Date: January 29, 2015

**Comment for the Draft Desert Renewable Energy Conservation Plan (DRECP)
and
Environmental Impact Report/Environmental Impact Statement (EIR/EIS)**

Preferred DRECP DFAs and Wind Speeds

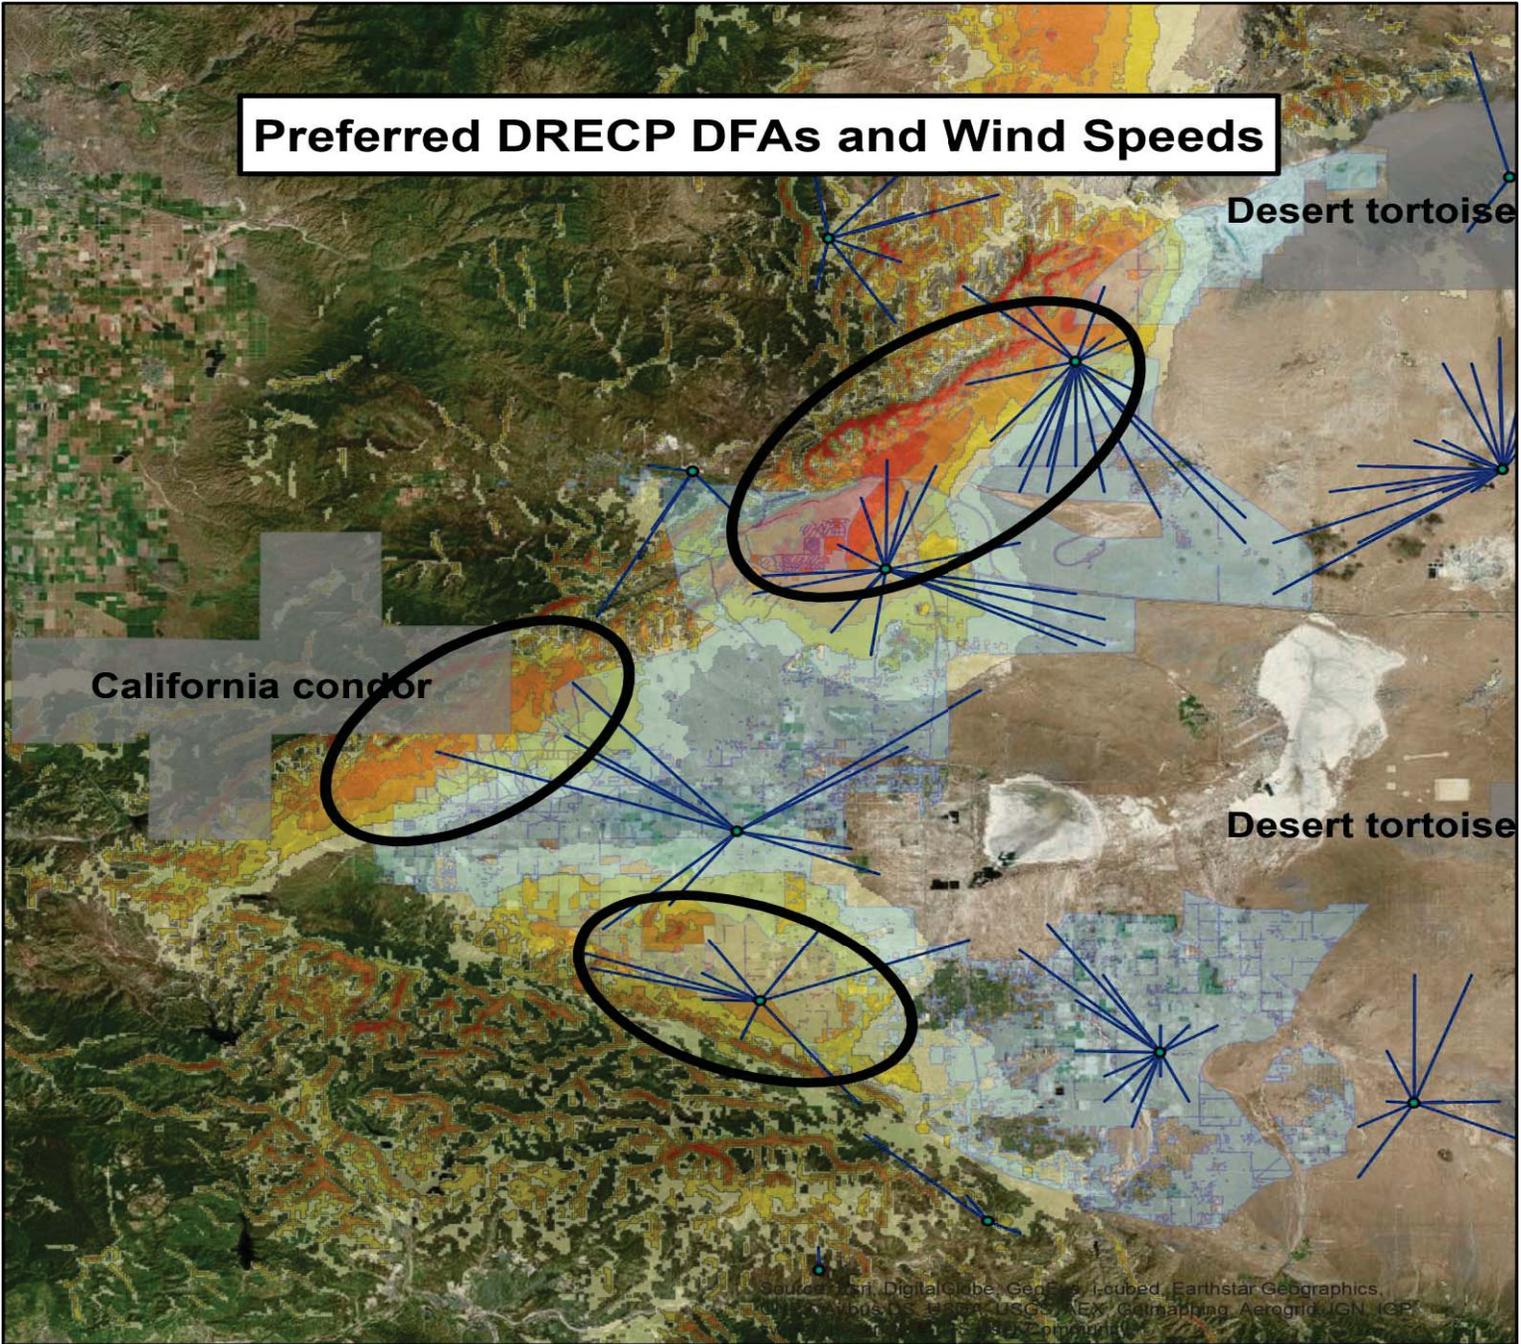
Within the black rings are high wind speeds for potentially successful wind projects. This land is part of DRECP's preferred land plan as DFAs, yet development of projects too close to the mountains incurs stunningly high costs, and county officials disallow any project near the condors due to concerns with Fish and Wildlife Services. Even with substantial spacing away from the condor areas, wind projects will either be shut down by the county without ample spacing, or be moved further away and, by doing so, lose any economic viability remaining from the vastly weaker wind speeds. The top right ring involves BLM land as well as established wind turbines. The bottom ring is within LA County, which involve solar farms, residential buildings, and protected conservation lands. Kern county officials have expressed interest in renewable energy projects, but without DRECP's intervention, development of renewable energy projects and improvement of surrounding economies cannot happen.

DRECP Land Coverage and Wind Areas

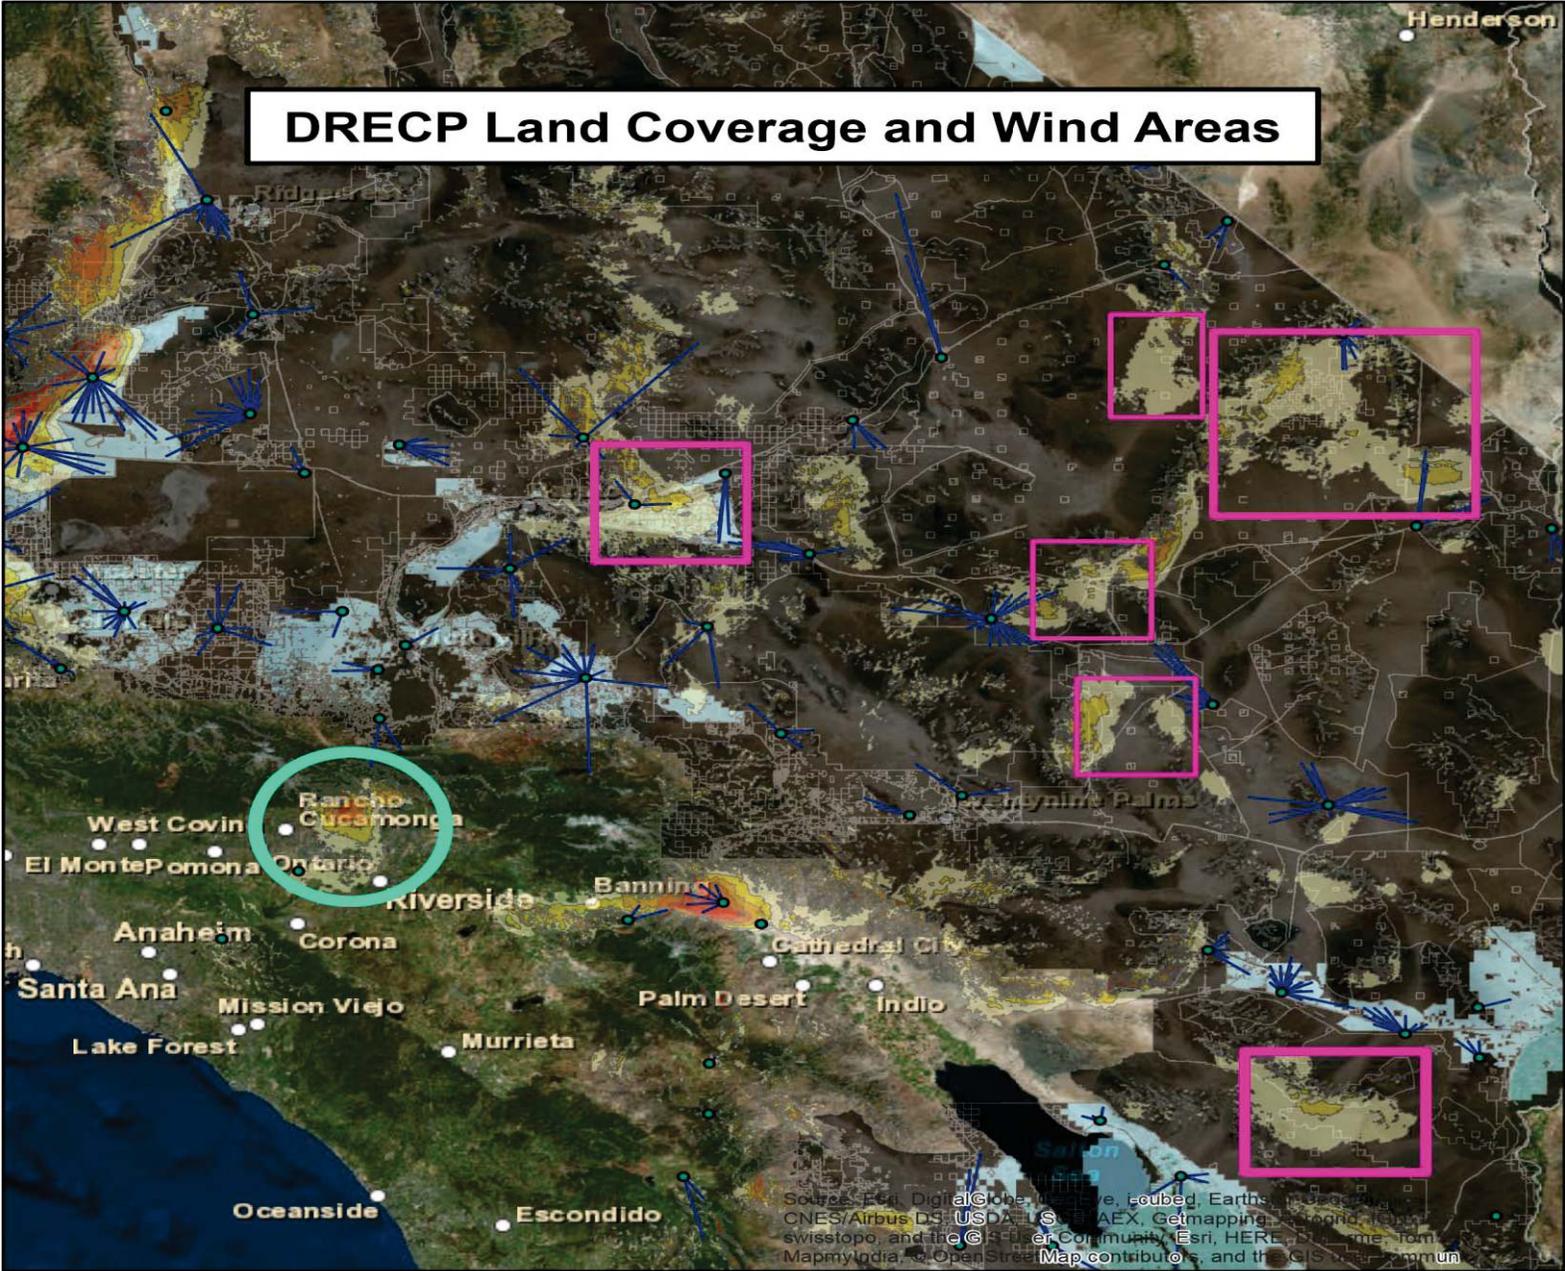
In this map, all within the dark gray areas are under the DRECP. However, within them, there are various good wind resource areas highlighted with magenta rectangles, but not labeled as DFAs. Southern California has very limited wind resources so we should not forego possible development in these marked areas, especially the general San Bernardino county desert area. We developers see the potential of new projects with already installed transmission lines around these marked areas. San Bernardino has not tried to push for any new projects for years due to eagles in the area, even in the incredible wind resource in Apple Valley (light blue circle). Still, just like the condor issue in Kern County, there are various mitigation efforts to keep the eagles safe from harm. Other than these areas, there is very little or weak wind resource in California. If DRECP can lend a helping hand in allowing more wind farm development areas, including special attention to Apple Valley's high wind resource, then more wind projects will be constructed to ensure a better future for all of us.
